*Preliminary Consultation*  
**MONTGOMERY COUNTY HISTORIC PRESERVATION COMMISSION**  
**STAFF REPORT**

<b>Address:</b>	7421 Cedar Ave., Takoma Park	<b>Meeting Date:</b>	2/8/2023
<b>Resource:</b>	Contributing Resource <b>Takoma Park Historic District</b>	<b>Report Date:</b>	2/1/2023
<b>Applicant:</b>	Pat Hanrahan Dana Haden, Architect	<b>Public Notice:</b>	1/25/2023
<b>Review:</b>	Preliminary Consultation	<b>Staff:</b>	Dan Bruechert
<b>Proposal:</b>	Alterations to Accessory Structure

1 NEW FRONT ELEVATION  
SCALE 1/4" = 1'-0"

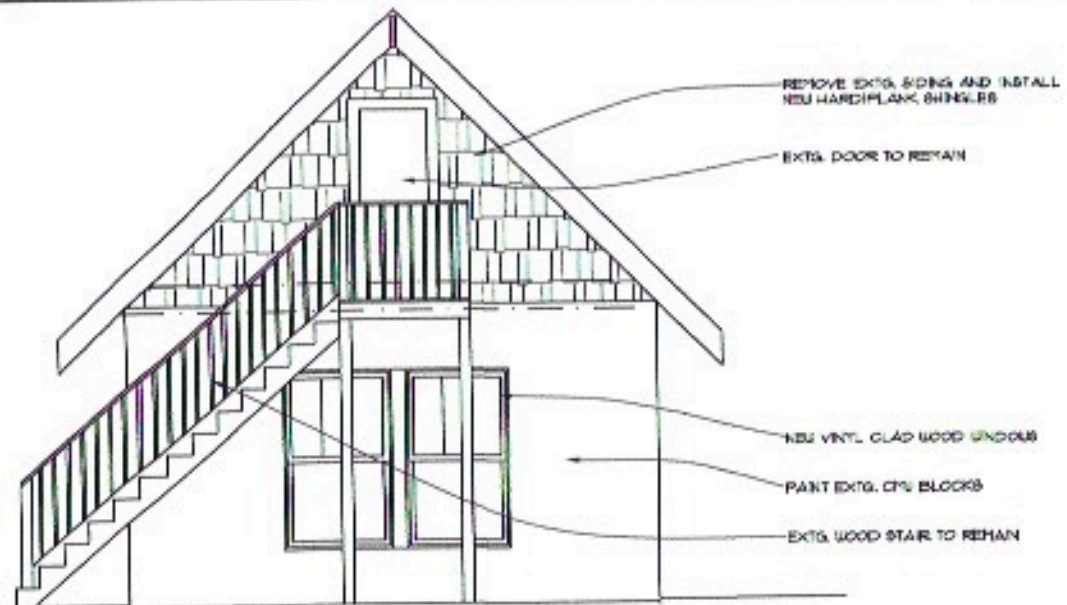
The most dramatic changes are proposed for the street-facing elevation. The existing elevation has a wood roll-up garage door with a shuttered upper-floor window. The applicant proposes to remove the existing garage door and install three sash windows and a full-lite door. The space below the sash windows will be filled in, but details for this feature were not provided. Above the new windows and door, the applicant proposes to construct a new shed roof with exposed rafter tails, supported by wood brackets that will project beyond the front wall plane by 3' (three feet). On the second floor, the applicant proposes to remove the existing asbestos shingle siding and install Hardie shingles and a new vinyl-clad sash window. Window and door specifications were not included in the submission.

Staff finds the existing garage door is not a historic feature and may be removed. In other projects where the HPC has considered garage-to-ADU conversions, the historic garage doors were extant and were retained and incorporated into the redesigned structure. While the form of the existing structure is clearly visible, Staff requests feedback from the HPC on the appropriateness of installing windows and doors with a residential-style window and door assembly. Would a carriage-style door, either operable or fixed, that retained the garage character be more appropriate in this location (see below)? Regardless, Staff finds that even though this is an accessory structure, that vinyl-clad windows are inappropriate because they are an inappropriate substitute material for wood or steel windows and because of the visibility of these elevations. Staff recommends that the infill windows be either wood or aluminum-clad window.

Staff finds the simple shed roof design is compatible with the character of the structure and the historic house and would recommend the HPC approve the alteration as part of the HAWP. Staff also notes that the proposed shed roof could be removed in the future without significantly impacting the fabric of the accessory structure.

The HPC has typically found that Hardie brand shake siding is an incompatible substitute material for wood shake because it is too narrow and too regular. However, the siding proposed for replacement appears to be asbestos shingle. Even though the proposed material is replacing a thin-profiled shingle siding, Staff recommends an alternative be considered and suggests either something like Hardie's panel vertical siding that resembles board and batten or the fiber cement shingles that replicate the appearance of the asbestos shingles.

1 NEW REAR ELEVATION  
SCALE: 1/4" = 1'-0"

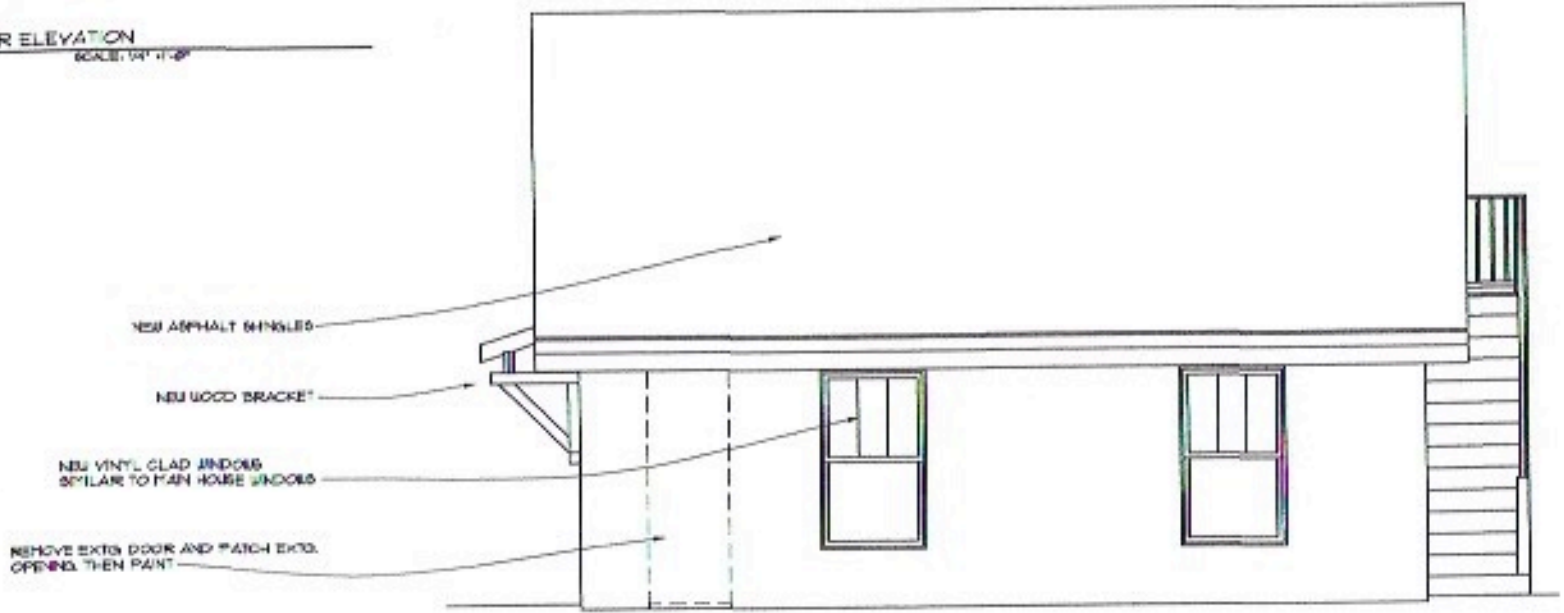
Both the right and left elevations of the existing garage have two steel casement windows. The applicant proposes to remove those windows and install three-over-one vinyl-clad sash windows in the openings. The drawings do not include measurements of the existing and proposed windows, however, they appear to be similar in size. On the right elevation, the applicant proposes to remove the existing door, patch the wall, and paint to match.

Staff finds removing the door on the right side will not impact the character of the structure and would recommend the HPC approves that change as a HAWP. As with the windows on the front elevation, even though this is an accessory structure, Staff finds that a vinyl-clad window is typically inappropriate and recommends either a wood or aluminum-clad window as a replacement. Staff recognizes that the sash window configuration was selected to match the design of the house. Staff would find a casement window with a similar configuration appropriate in these elevations. Finally, Staff requests measurements of the existing and the proposed windows with the HAWP application to compare the window sizes.

At the rear, the applicant proposes to retain the existing exterior wood stairs and upper floor door, while replacing the existing steel windows with vinyl-clad sash windows and replacing the existing shake with Hardie shingles.

As discussed above, Staff recommends an alternative treatment for the siding in the gable and encourages the HPC to identify any other appropriate materials.
